Subject: Rice Solar Energy Project (09-AFC-10)
Response to CEC Workshop Query 12

Response to CEC Staff Workshop Query 12

Rice Solar Energy Project

Elimination of the Stormwater Detention Basin

**FIGURE WSQ12-2C
CONCEPTUAL GRADING AND
DRAINAGE PLAN CROSS SECTIONS**
Rice Solar Energy Project
Riverside County, California

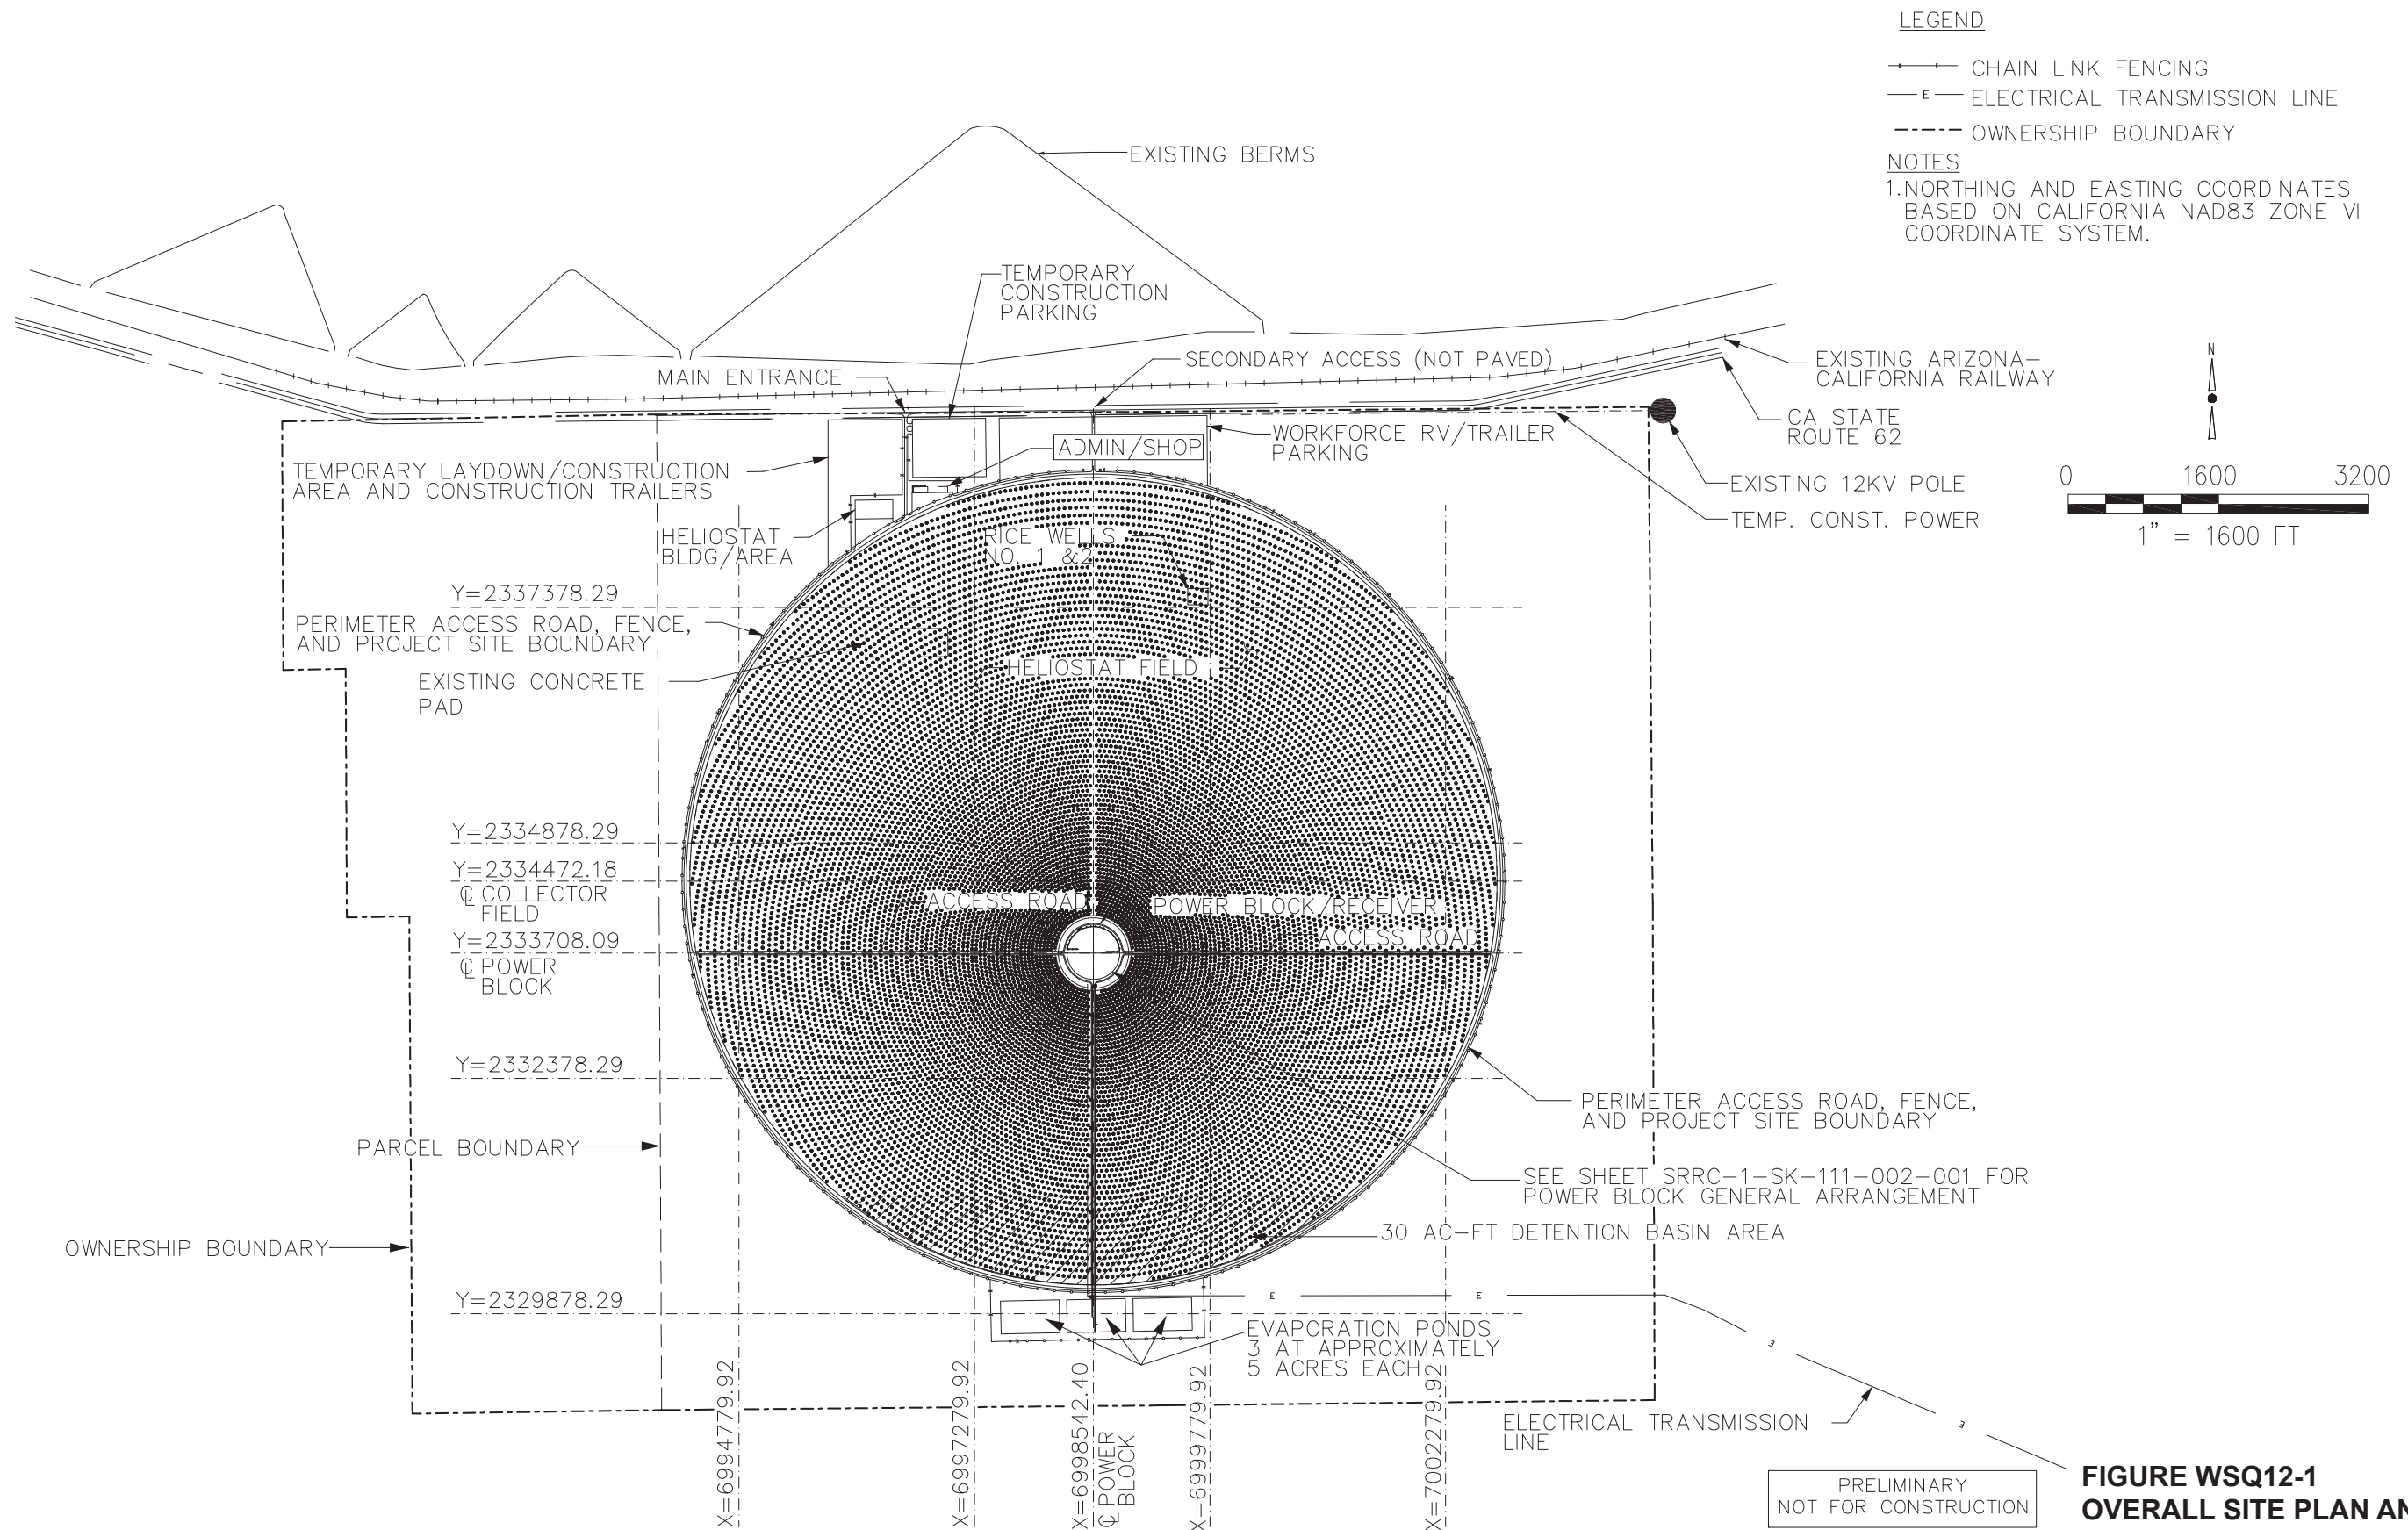
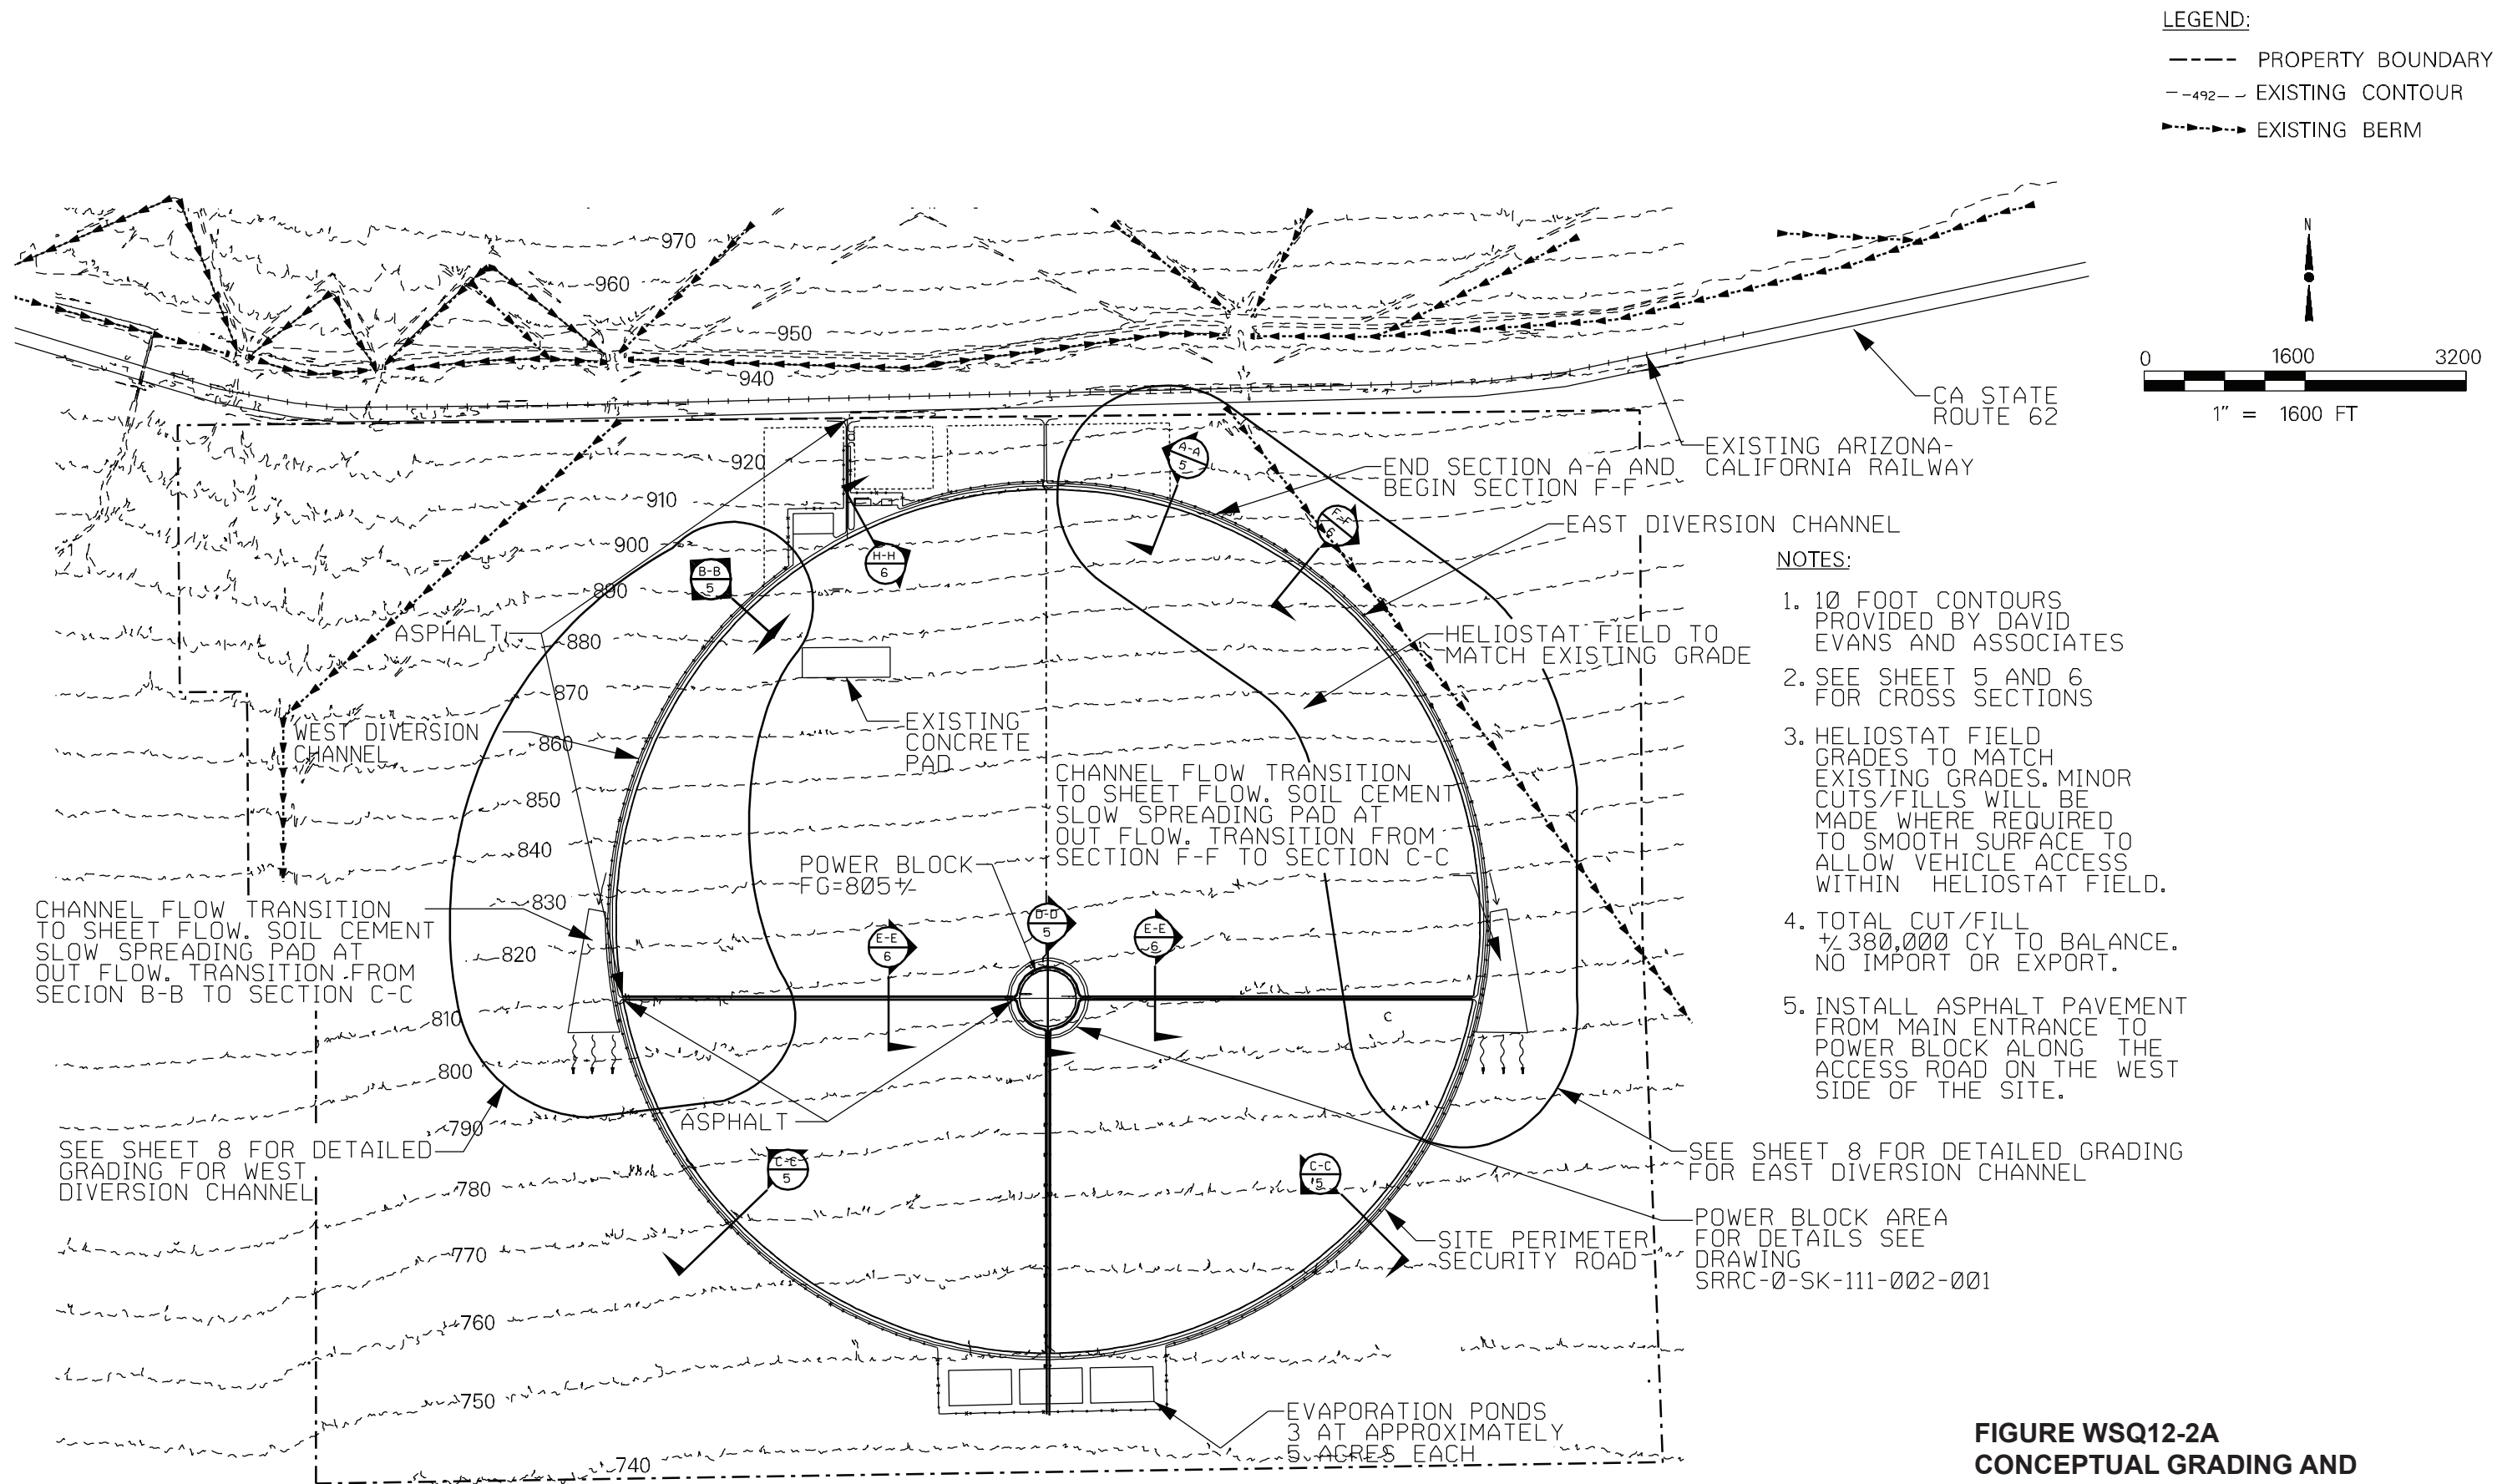
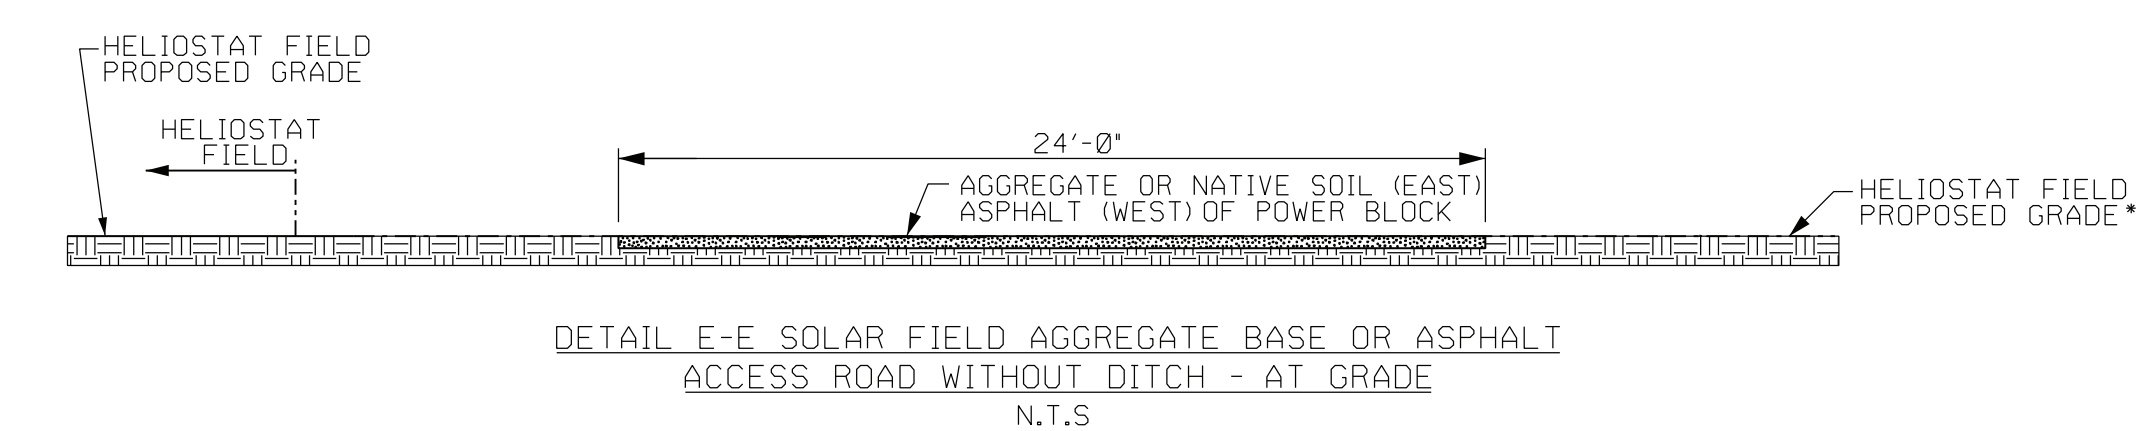
WSQ 12 Please provide a revised General Arrangement and associated drawings that depict the elimination of the stormwater detention pond, and provide a discussion of whether this is a feasible design.

- AFC Figure 2.2-1, Overall Site Plan and Conceptual General Arrangement (Figure WSQ12-1)
- Figure DR68-1a, Conceptual Grading and Drainage Plan (sheet 4, Figure WSQ12-2a)
- Figure DR68-1b, Conceptual Grading and Drainage Plan Cross Sections (sheet 5, Figure WSQ12-2b)
- Figure DR68-1c, Conceptual Grading and Drainage Plan Cross Sections (sheet 6, Figure WSQ12-2c)

It would be feasible to eliminate the stormwater detention basin and construct the southern perimeter loop road at grade. As shown on the drawings, the heliostat perimeter road would be constructed at grade under this alternative, and the detention pond would be eliminated. Under this alternative, onsite stormwater flow would not be directed to a detention basin and the onsite storm flows would tend to follow their current drainage pathways across the heliostat field loop road offsite to the south. Using this design, increases in stormwater flows would not be mitigated by detention and slow release, as with the detention pond design.
